Re: Turkey Point Unit 3
Docket No. 50-250
Order (EA-03-009) Relaxation Request
Examination Coverage of Reactor Pressure Vessel Head
Penetration Nozzles - Supplemental Data

**TURKEY POINT UNIT 3 RELAXATION REQUEST
FROM US NRC Order EA-03-009**

RESPONSE TO REQUEST FOR ADDITIONAL INFORMATION

Figure 1: Typical RPV Nozzle UT Inspection "C" Scan with area of missed coverage identified by arrows and above the white horizontal line.

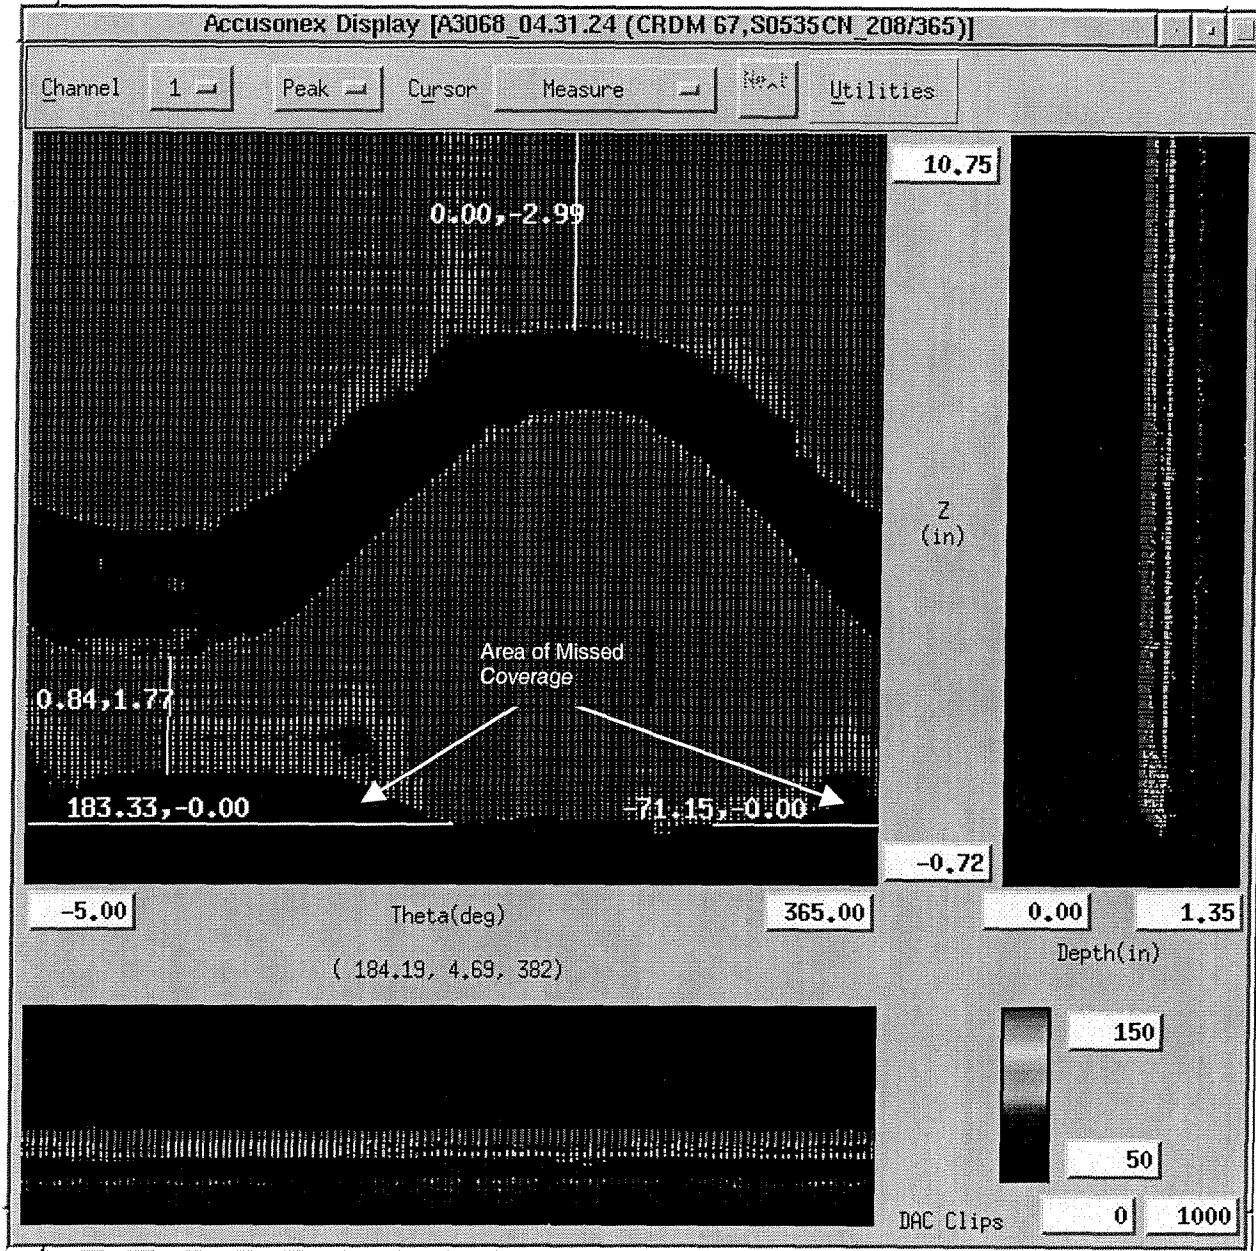
Question 3. In Figure 1 of the submittal, the degrees of missed coverage for control rod drive mechanism (CRDM) 67 are listed as 60.27 and 175.79 for a total of 236.06 degrees. In Table 2 of the submittal, a comment for CRDM 67 states “coverage below weld from 343 degrees - 170 degrees.” What is the area of missed coverage for this nozzle, how is it determined and how does one reconcile the information provided in the C-scans with the table?

Previously, Figure 1 was included to depict a “typical” example for nozzle #67. The figure 1 that is included in the supplemented request is the actual C-scan for nozzle #67 that illustrates the circumferential extent of missed coverage. The extent of missed coverage at the bottom of the nozzle is determined by, in this case, adding the two numbers. Additionally, the total circumferential extent of missed coverage, in degrees, is now shown in Table 2 for every nozzle where coverage was less than 100%.

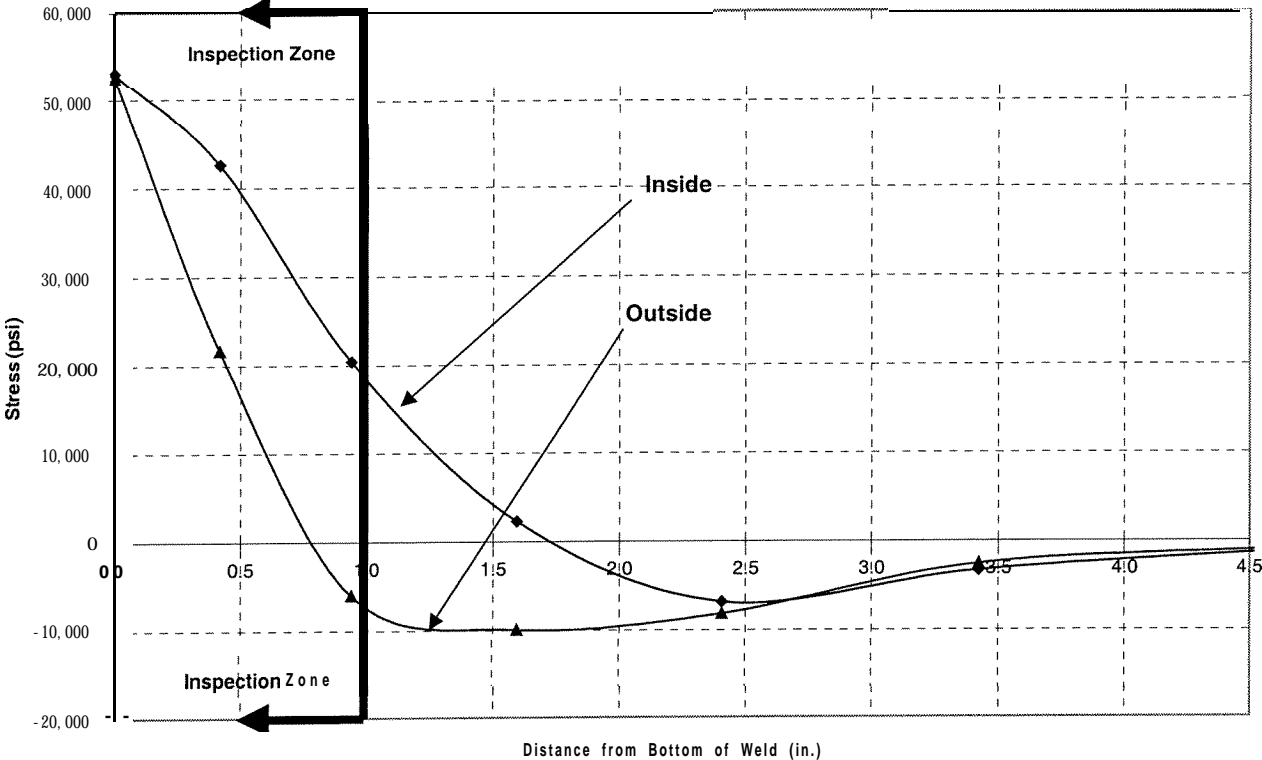
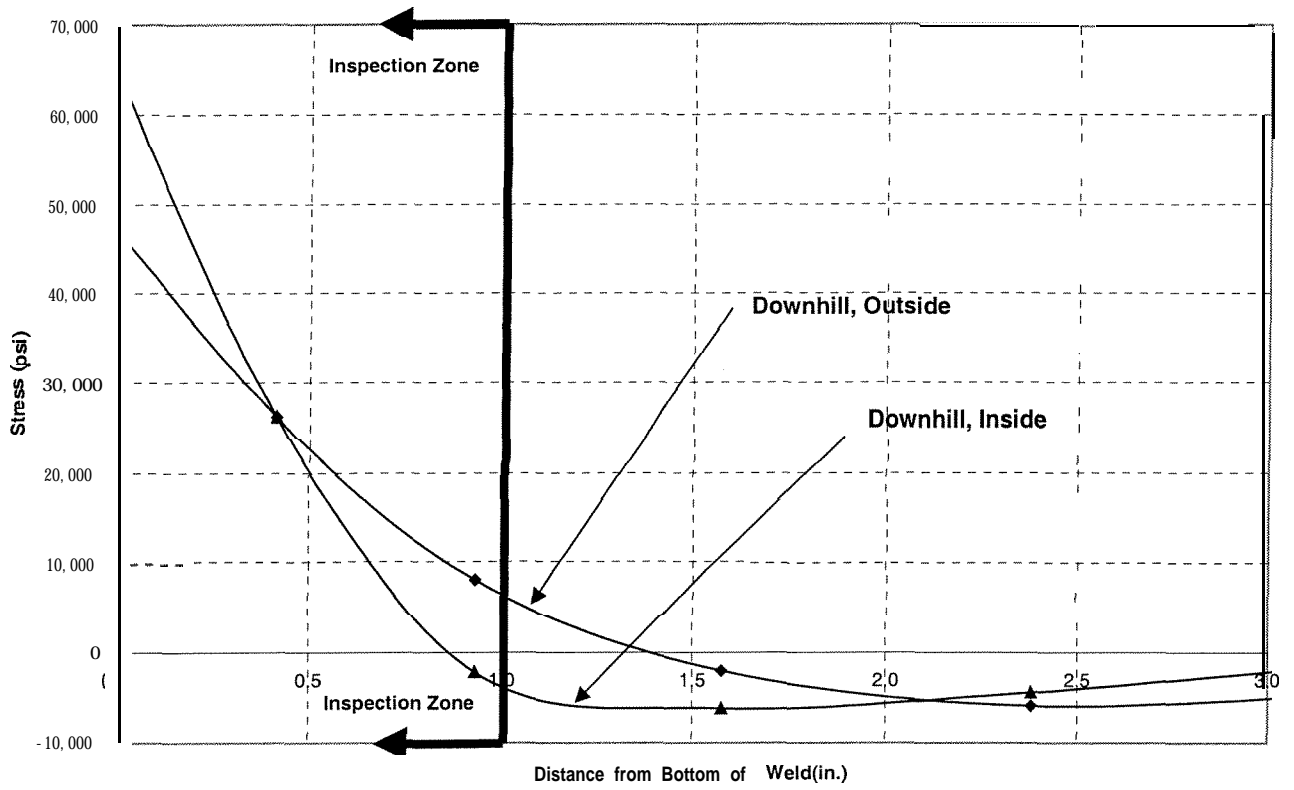
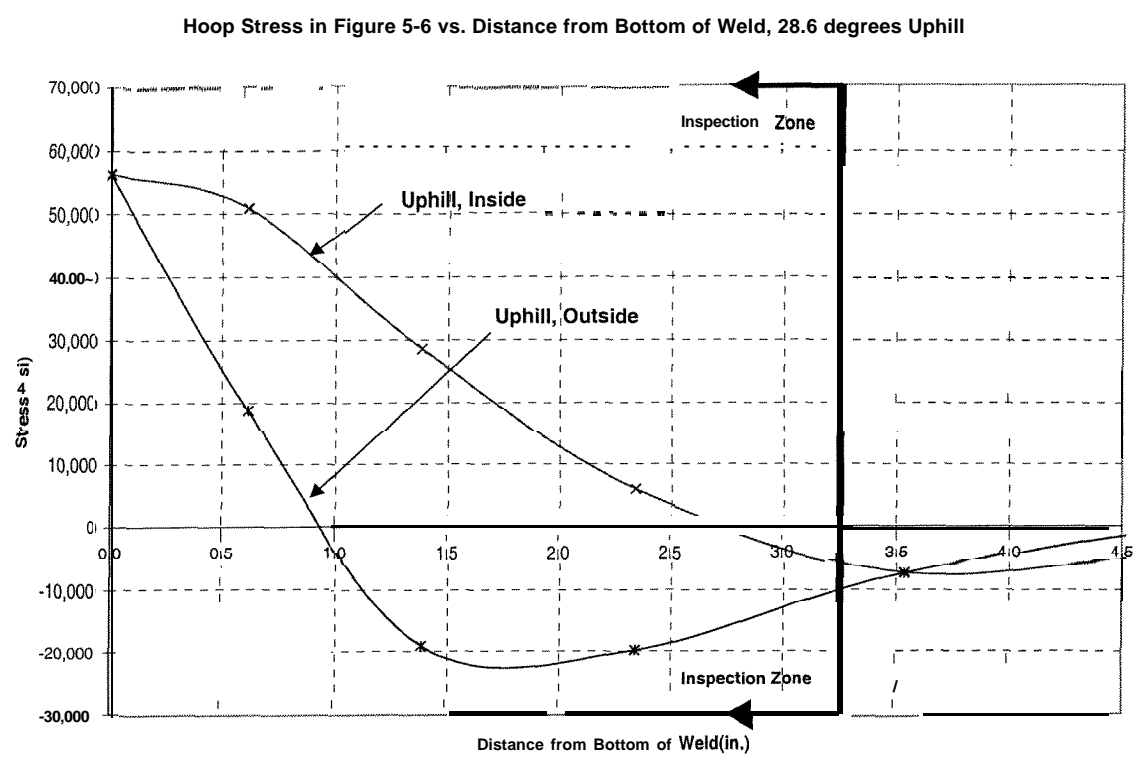
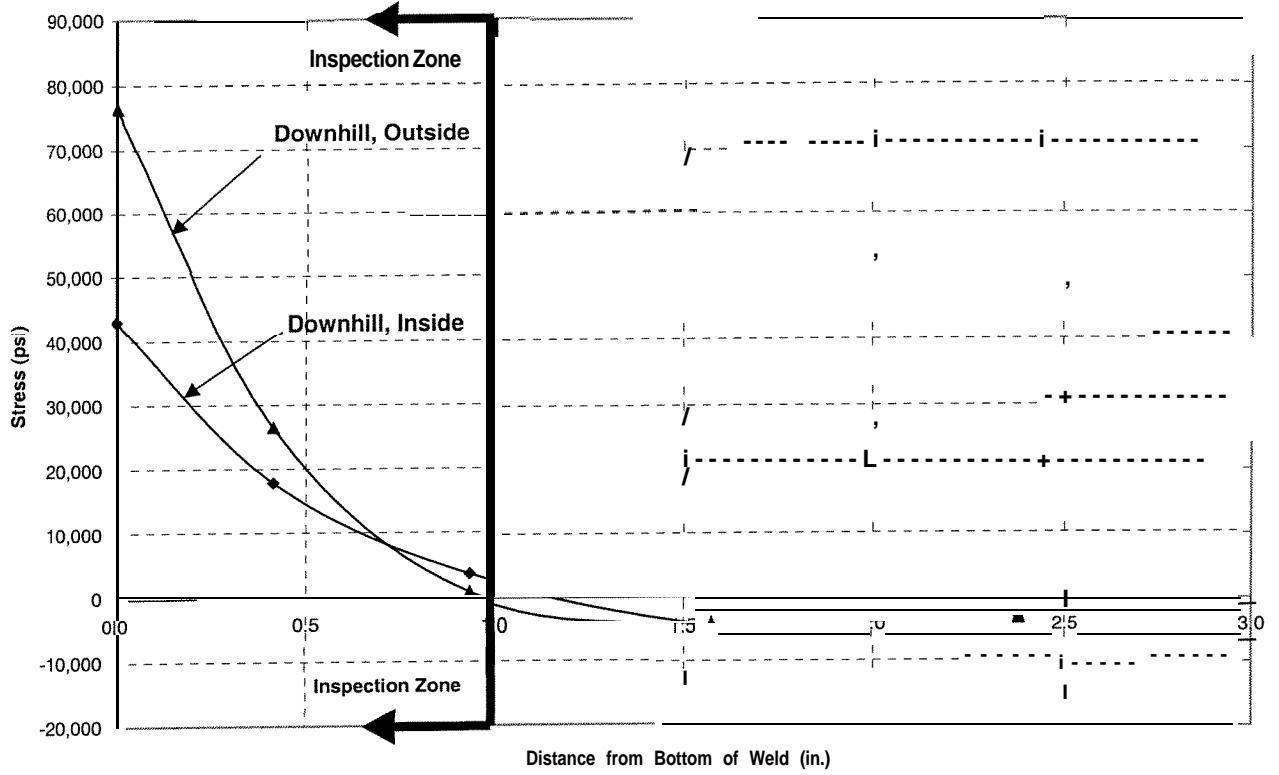
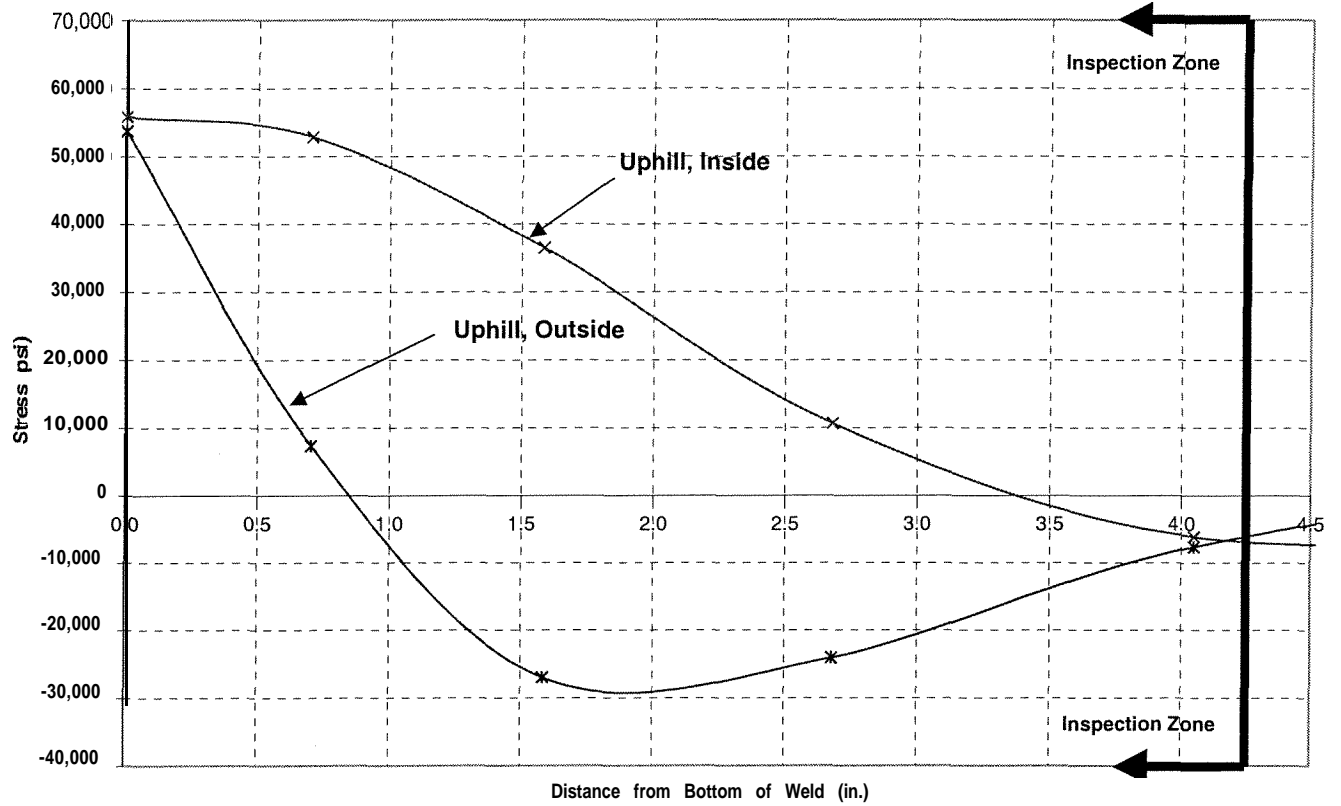
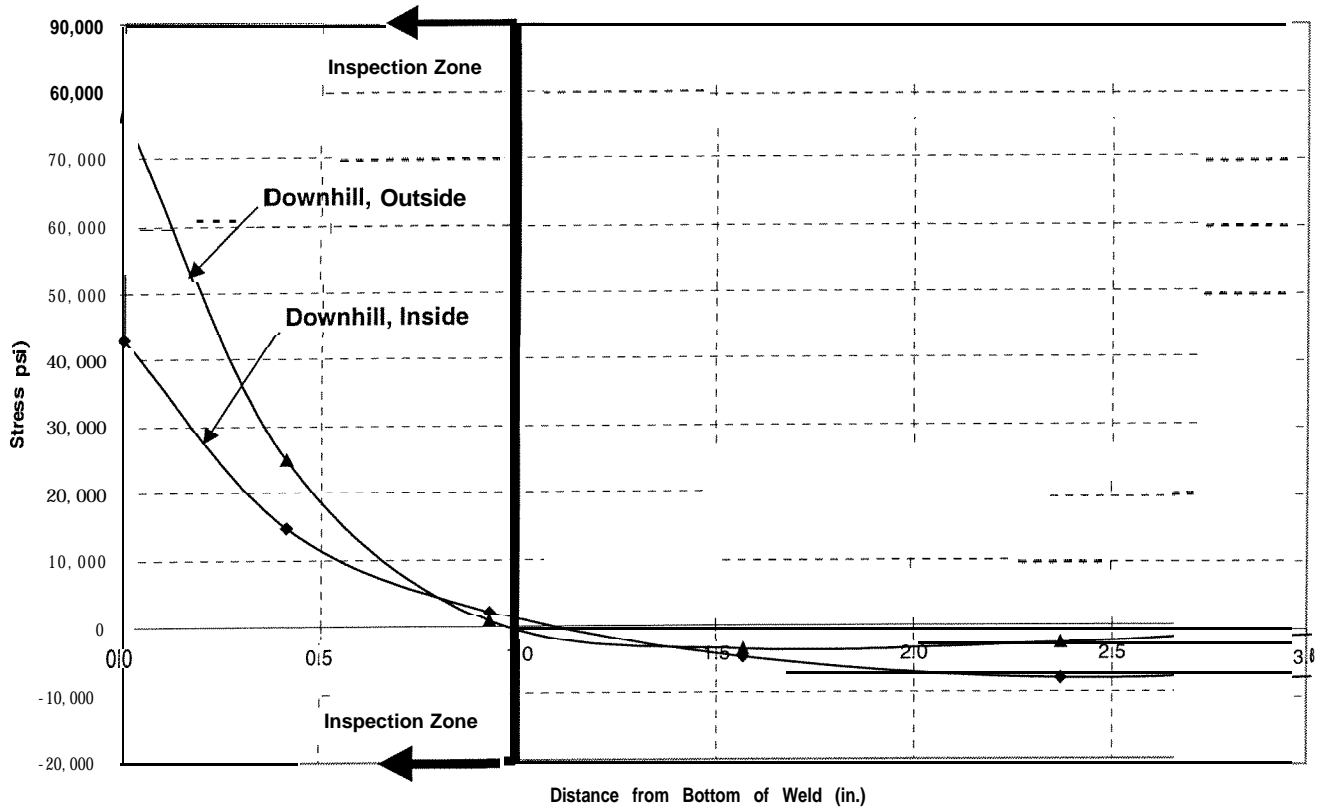
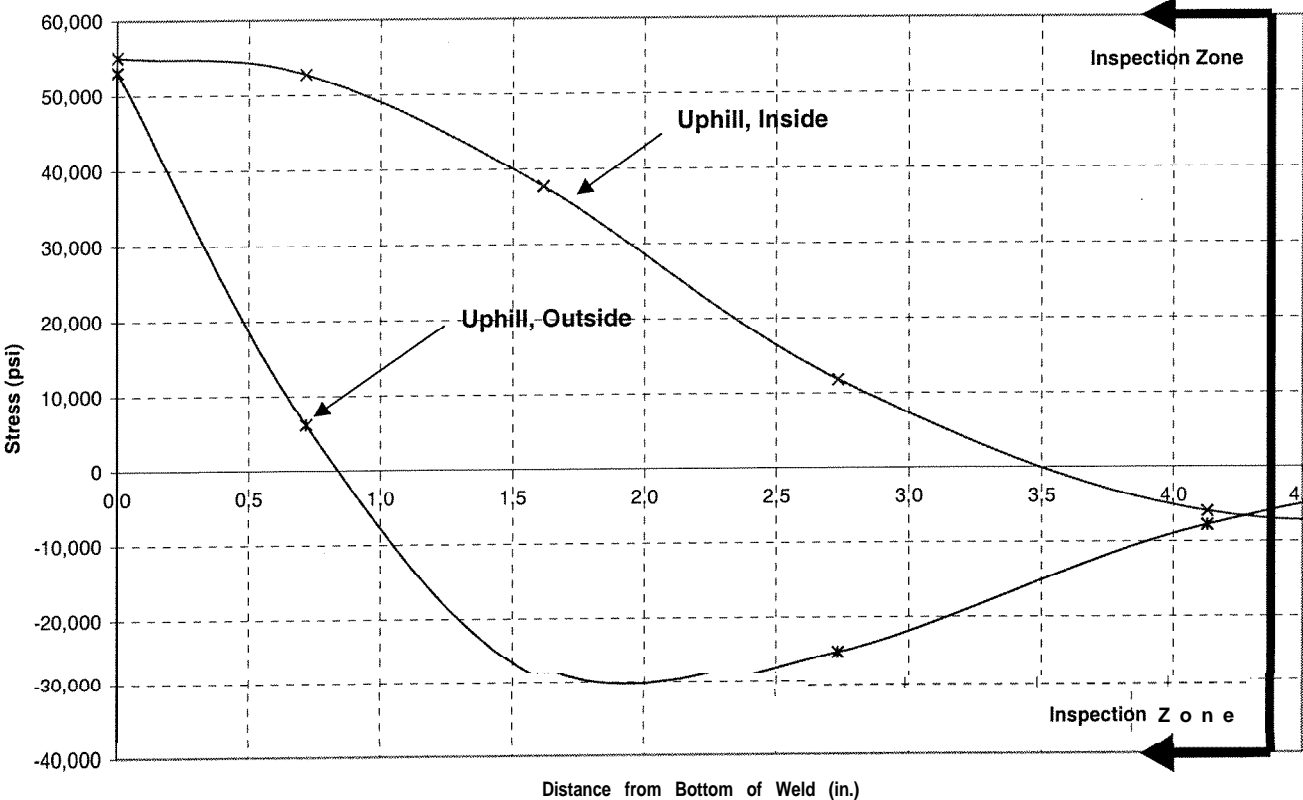
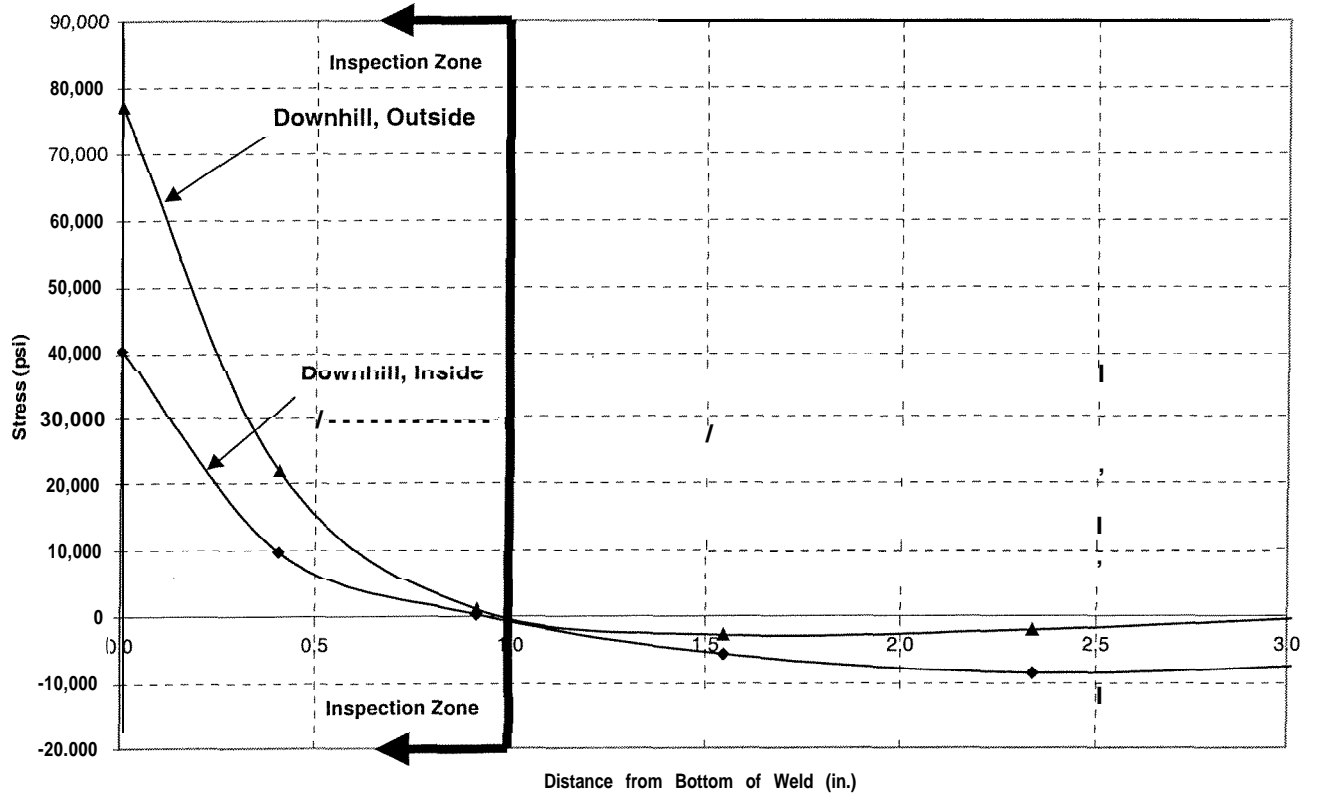
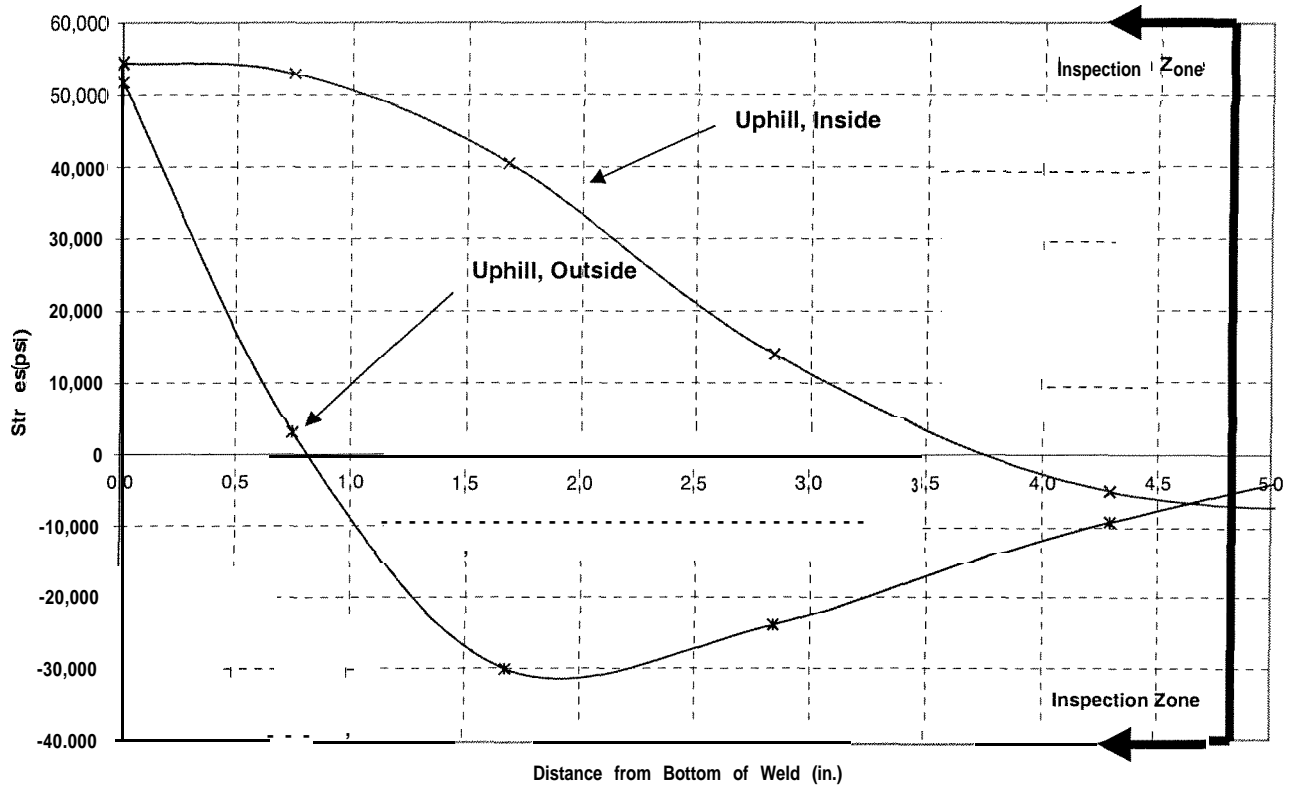
Question 1. In Figures 5-3 through 5-9 of WCAP-16027-P, what is the maximum hoop stress in the nozzle base material greater than one inch from the bottom of the weld? What material properties (i.e., yield strength) were used in these calculations?

The hoop stress distribution as a function of distance from the bottom of the weld shown in Figures 5-3 through 5-7 of WCAP-16027-P are provided in Figures 1 to 9. Hoop stress in Figure 5-8 of WCAP-16027-P for the head vent penetration below the weld is not available because the penetration does not extend beyond the attachment weld. Figure 5-9 of WCAP-16027-P is an axial stress distribution plot of CRDM (42.6") and the corresponding hoop stress distribution as a function of distance from the bottom of the weld for this nozzle is given in Figures 8 and 9. Note that the minimum distance below the weld toe depicted on Table 2 typically occurs at the downhill side of the welds. Coverage at the uphill side is greater, and varies with the angle of the penetration. This difference in distance below the weld is approximated in Figures 1-9 contained herein.

Our inspection vendor does not currently have eddy current capability. This is the only method available for inspecting the inside surface of the affected penetrations, due to the accessibility restraint provided by the installed thermal sleeves. The available method for performing outside surface inspections is manual PT. Preparation and inspection of the subject outside surfaces would increase exposure, without obtaining information leading to a corresponding increase in safety, due to the low stresses in the affected zones. As shown in Figures 1-9, these stresses range from small tensile stresses to mostly compressive stresses.
